PZ&B Staff Combination Memorandum: Architectural Commission and Town Council

SUBJECT: ARC-23-120 (ZON-23-088) 1600 S OCEAN BLVD (COMBO)

MEETING: NOVEMBER 20, 2023 ARCOM

DECEMBER 13, 2023 TOWN COUNCIL

Cooling tower and folly location on site plan.

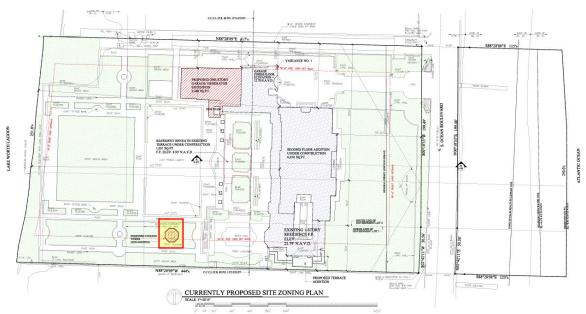
Staff will note that the applicant has not provided elevations of the cooling tower folly for review, which could result in variances.

1Previously proposed height variance, now reduced.

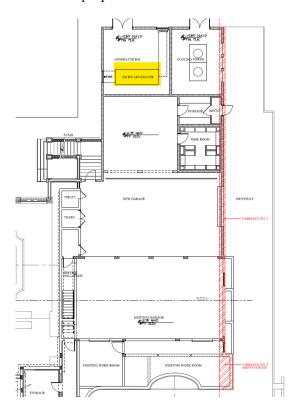
As it pertains to **Variance #1**, a variance to permit an increase in building height (parapet) within the north side-yard setback, the applicant is proposing to raise the parapet on the structure and addition within the required north side-yard.
